**Notice of Allowability**

10/768,530

RICHARDS ET AL.

Figure 1.

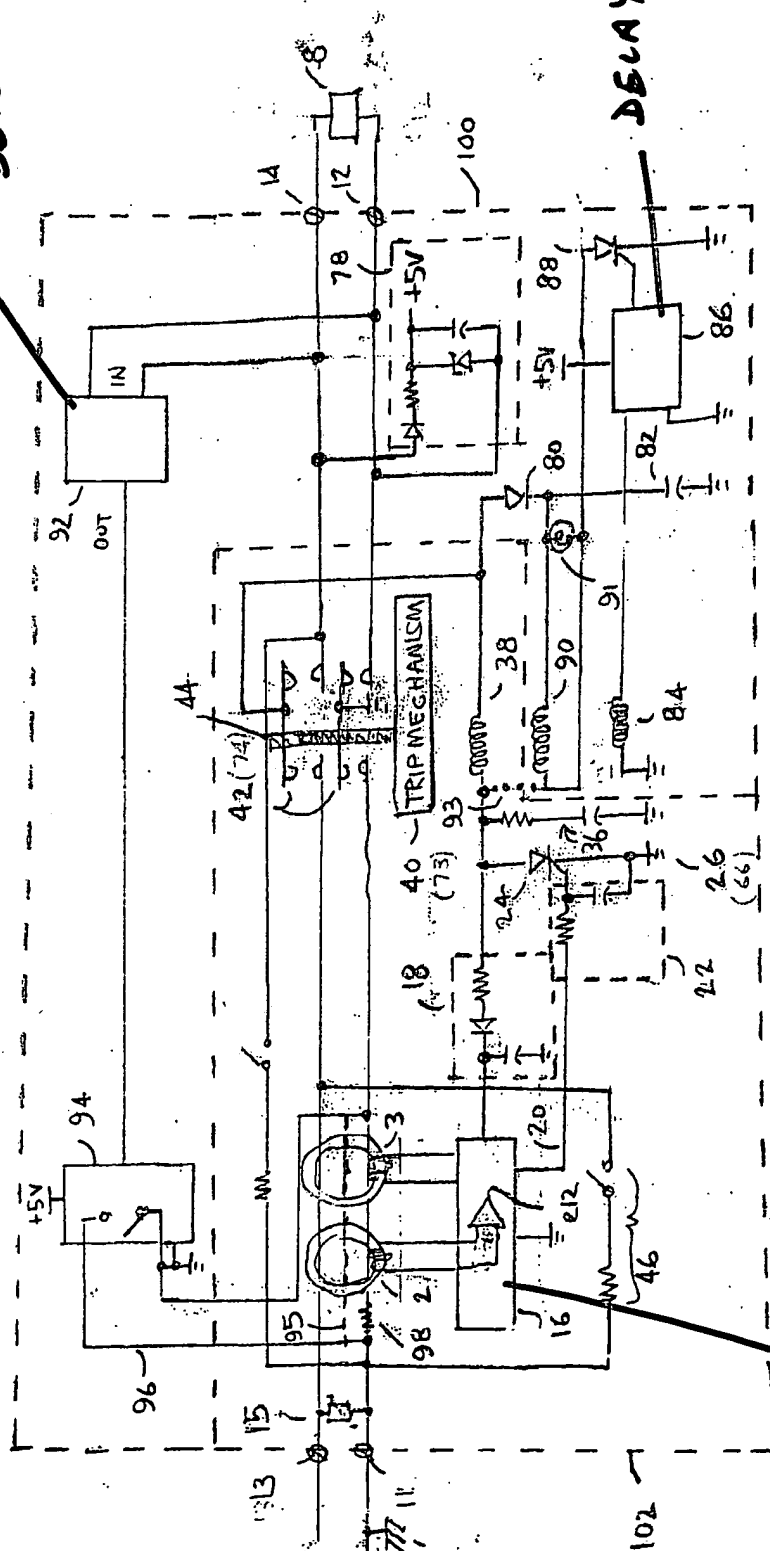
In the drawing, Figure 1 (see attached drawing corrections),

- added descriptive label --POLARITY DETECTOR--for box 92
- added descriptive label -- GROUND FAULT DETECTOR -- for box 16
- added descriptive label -- DELAY TIMER -- for box 86

3. New formal drawings in compliance with 37 CFR 1.121(d) are required in this application because they are hand drawn and lettering and numerals are difficult to read.

POLARITY  
DETECTOR

DELAY TIMER

GROUND FAULT  
DETECTOR
